**RE: CONTRACT NO.: 13/WSD/17
DESIGN, BUILD AND OPERATE FIRST STAGE OF TSEUNG KWAN O
DESALINATION PLANT
Submission of Detailed Design Plan for Chlorine and Carbon Dioxide Storage
of Desalination Plant**

Detailed Design Plan for Chlorine and Carbon Dioxide Storage of Desalination Plant

**First Stage of Desalination Plant at Tseung Kwan O – Investigation, Design and Construction
Detailed Design Plan for Chlorine and Carbon Dioxide Storage of Desalination Plant
IEC Verification Letter**

Submission No.	TKOD1-RPT-A000-JGN0003-04		
Subject	Submission of Detailed Design Plan for Chlorine and Carbon Dioxide Storage of Desalination Plant	Date	9/07/2021
Version	04	Page	1 of 2

©COPYRIGHT RESERVED

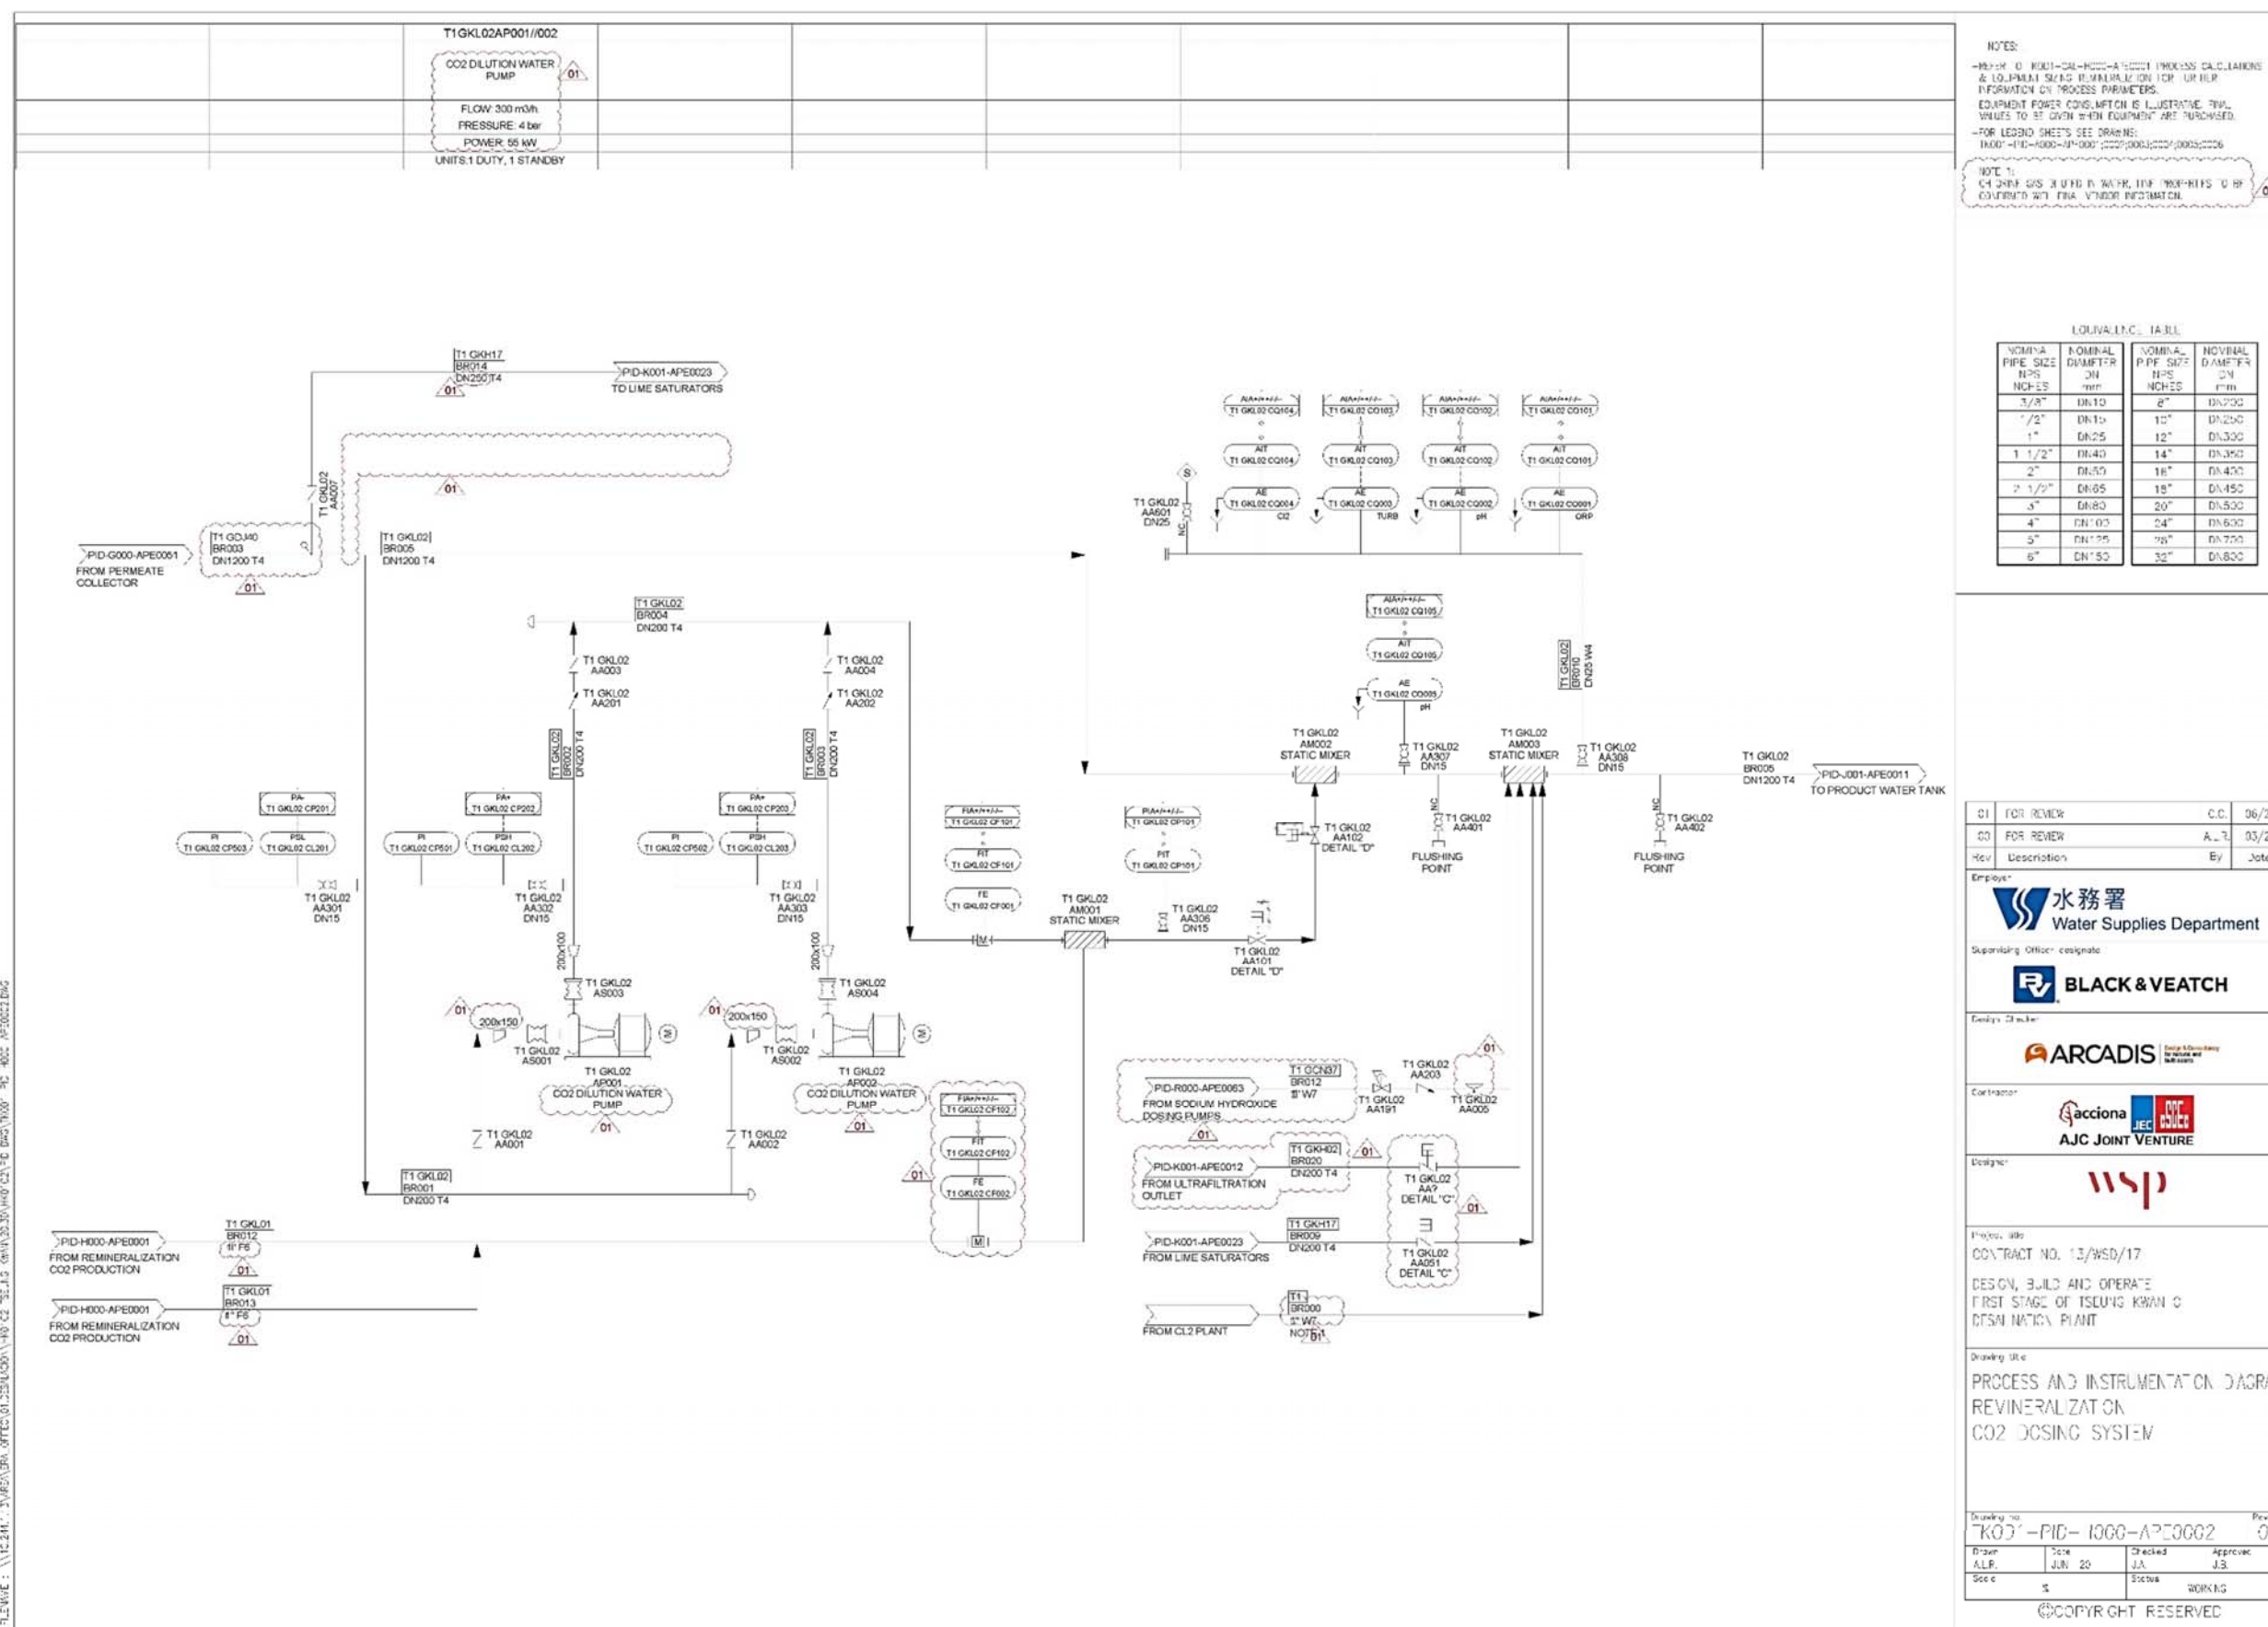
2. Appendix B Please explain how the design of the pressure relief valves system can avoid common mode failure.	Explanation has been added in Appendix B-5 of the revised plan. The P&IDs in Appendix B-2 have also been revised.

Appendix B - 5: Pressure Relief System of Inner and Outer Vessel of Insulated Tank and Carbon Dioxide Road Tanker

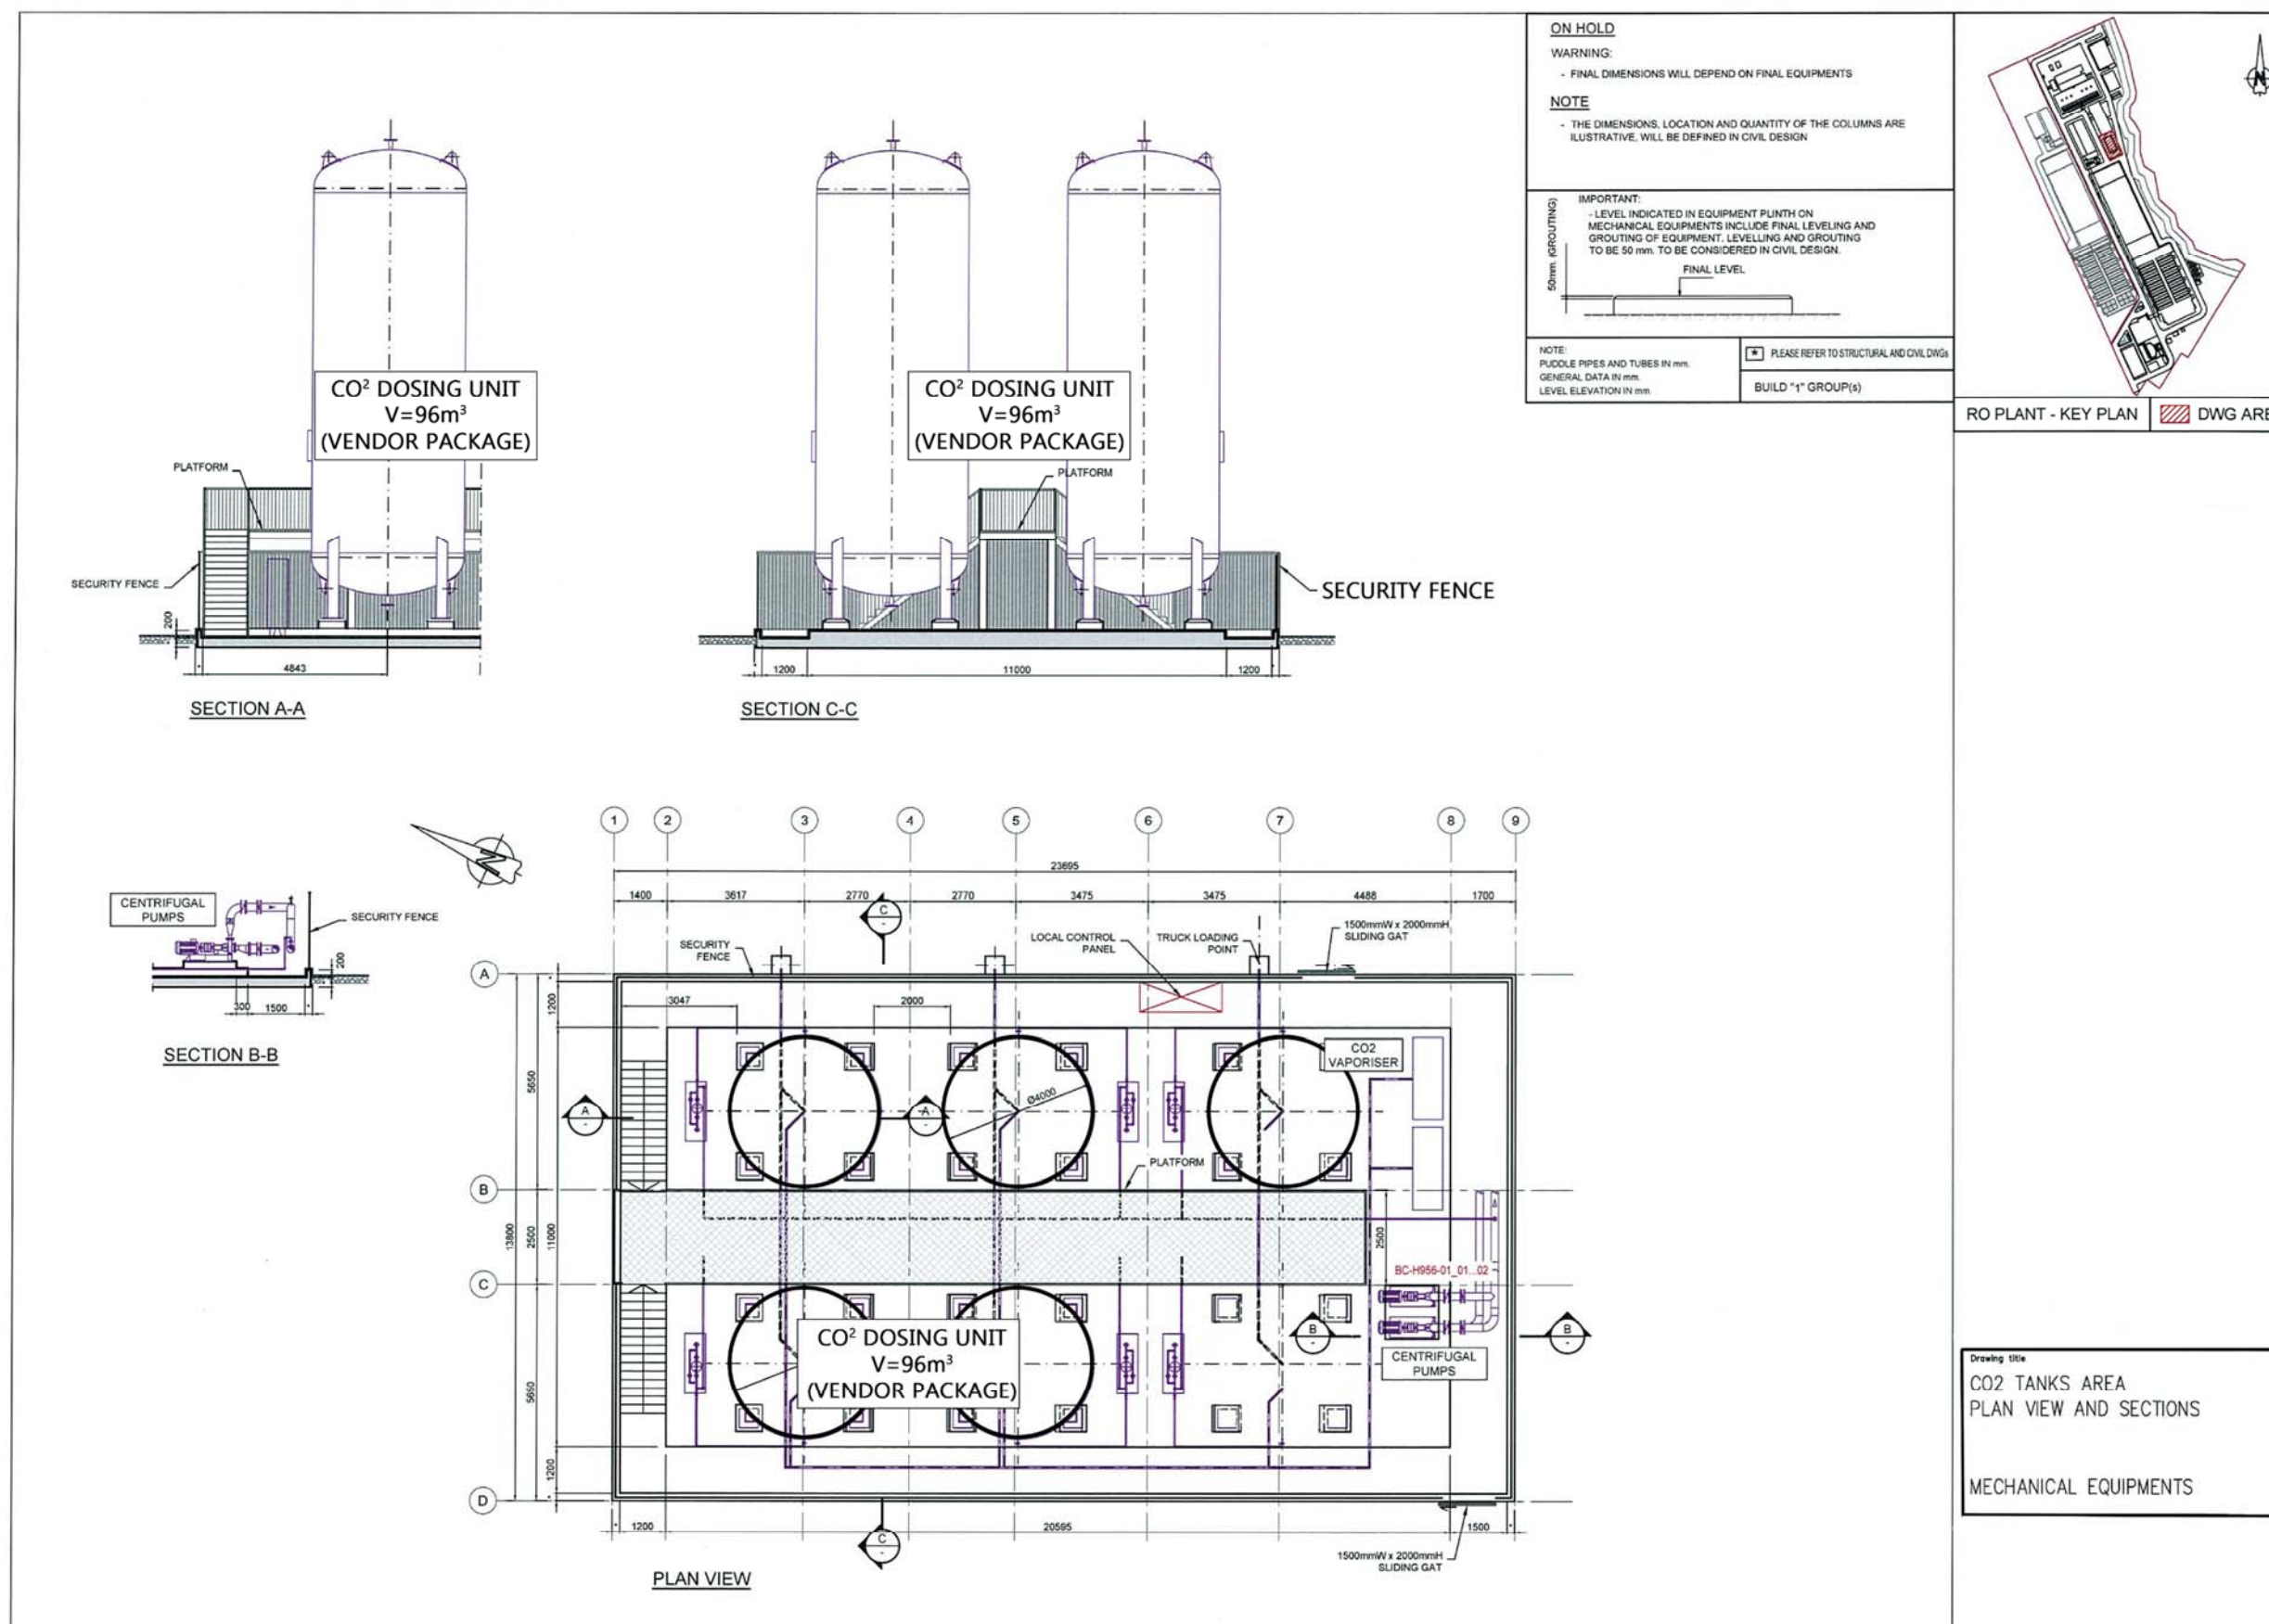
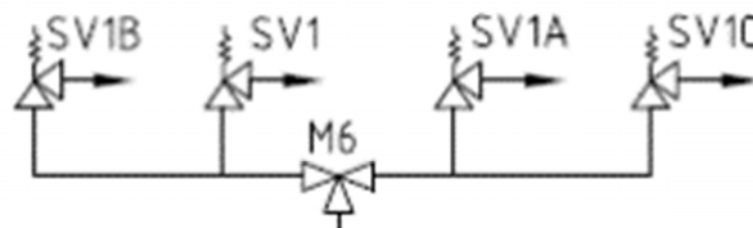
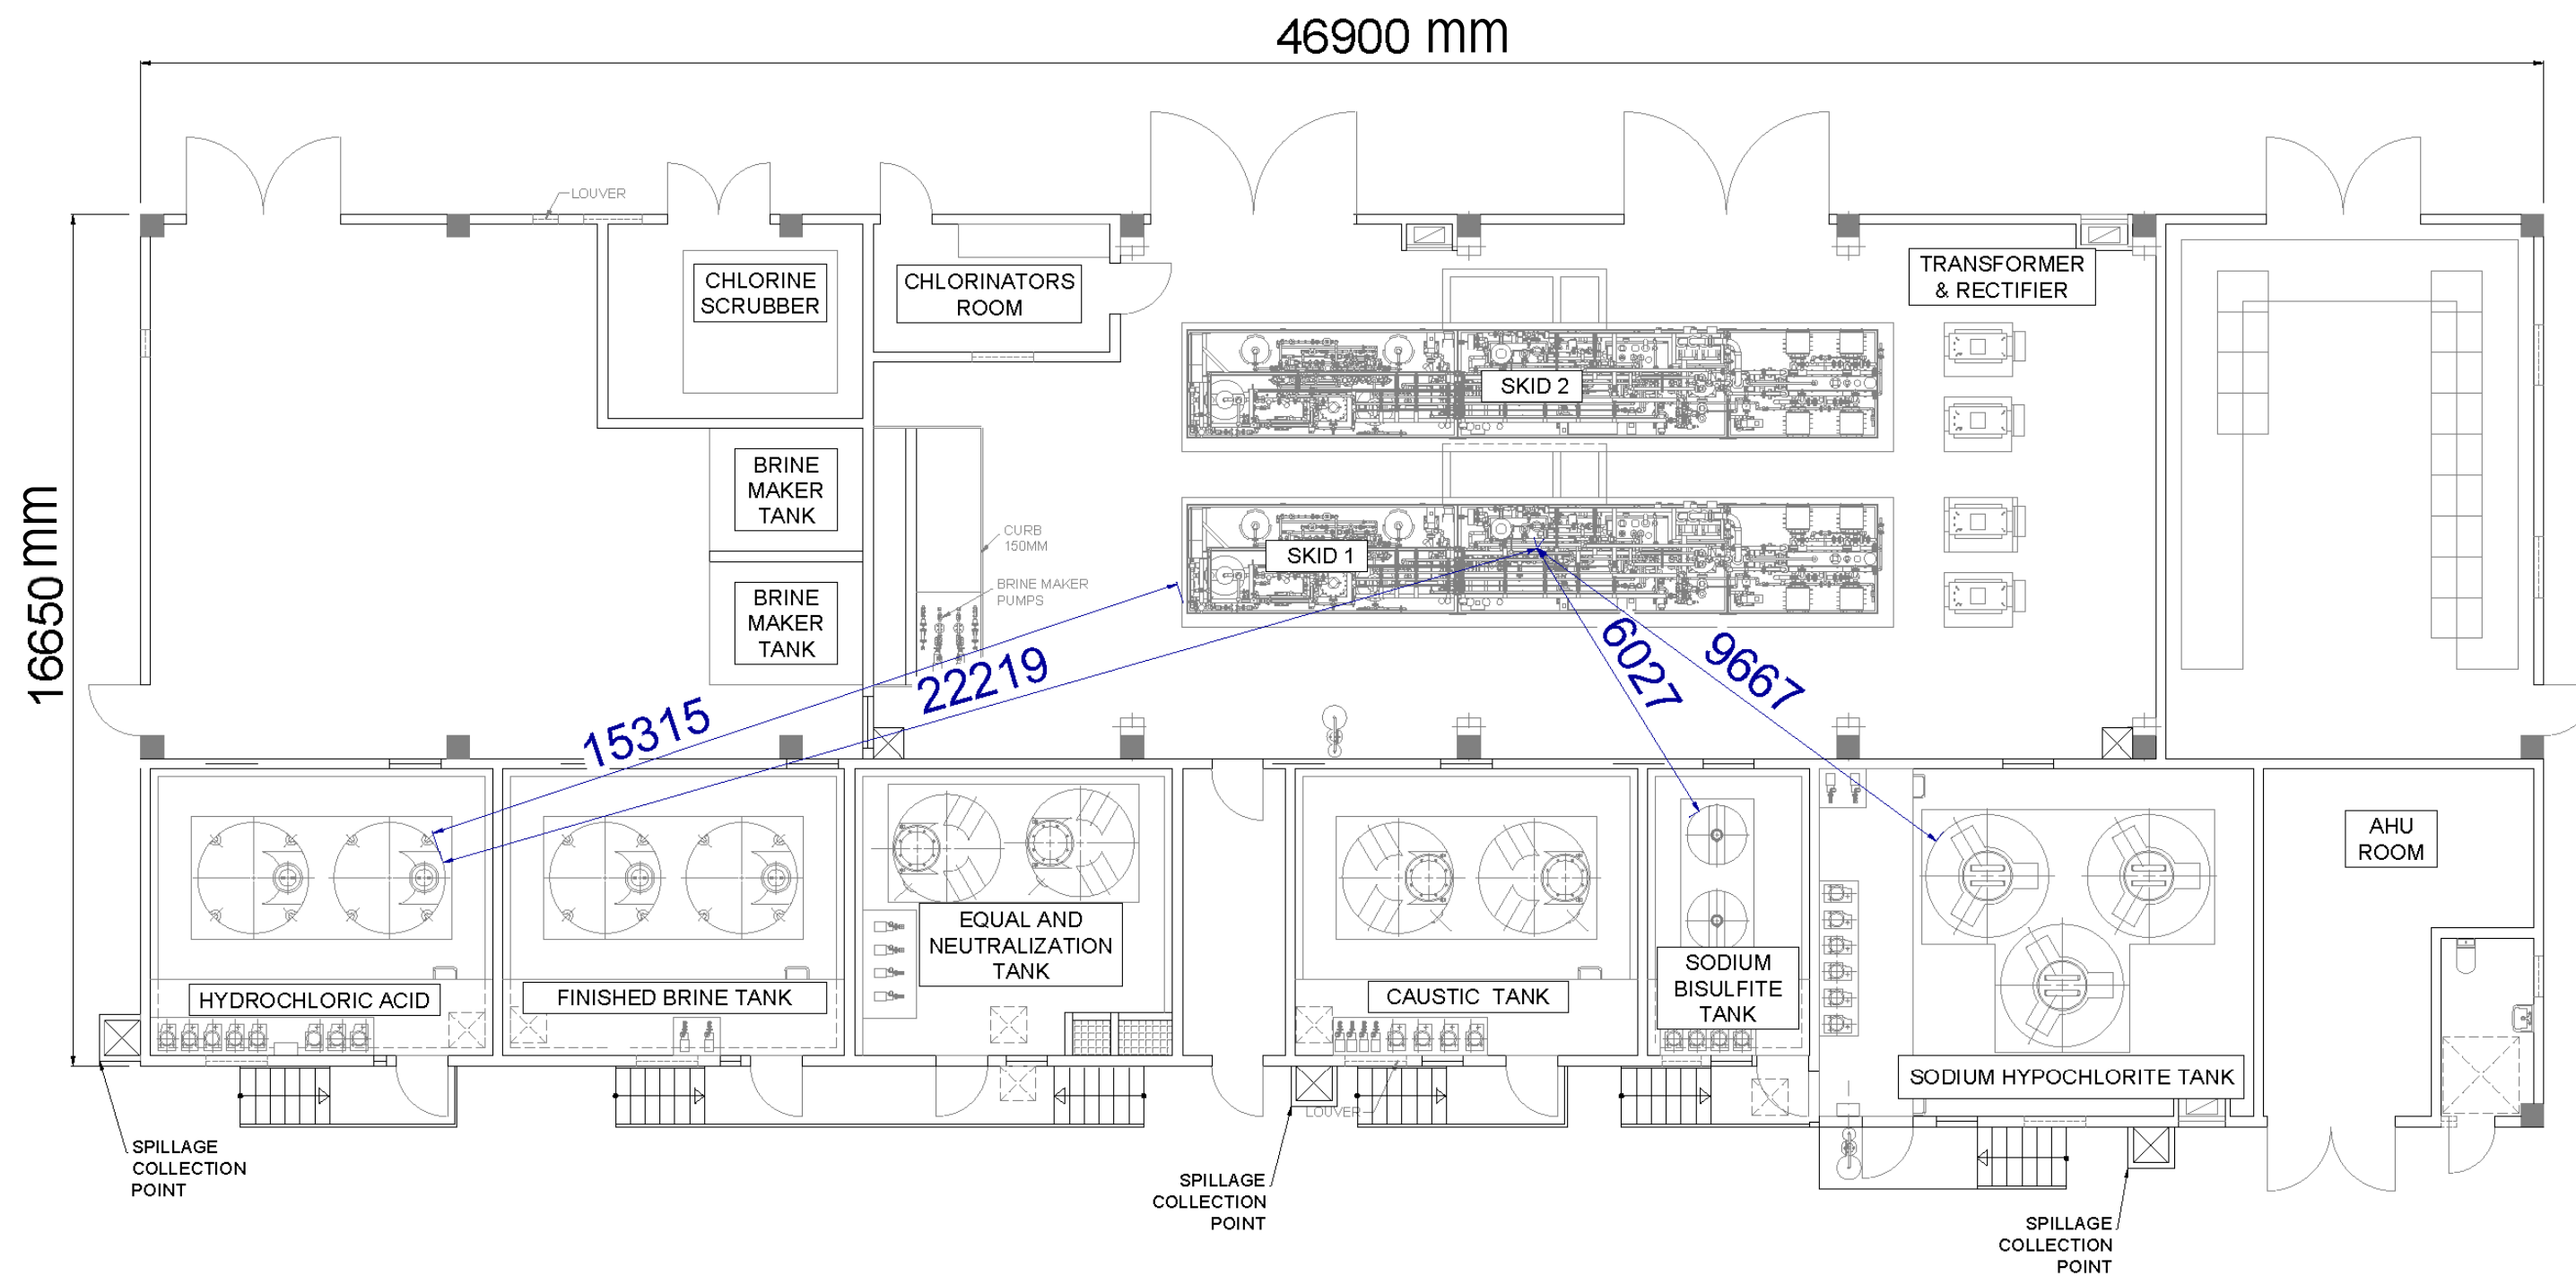
1. Appendix A, Item 2.5 Please clarify whether the explanations in Appendix B-5 are also applicable to carbon dioxide road tanker	Explanations in Appendix B-5 are also applicable to carbon dioxide road tanker. Text has been added in Item 2.5 of Appendix A and title of Appendix B-5 to clarify.

1. Two sets of relief valves, one duty and one standby. Such design allows annual calibration without interrupting the system.
2. There is a 3-way diverter valve to switch between duty and standby. Design of valve ensure opening at either side (ie. Either to left or right). There will not be accidental closing of both streams.
3. Each side consists of two relief valves in two settings, usually at 22 barg and 24 barg. The two stage design allows double protection. In case pressure rises too quickly that the first stage valve cannot release the pressure, there is the second stage relief valve for protection.
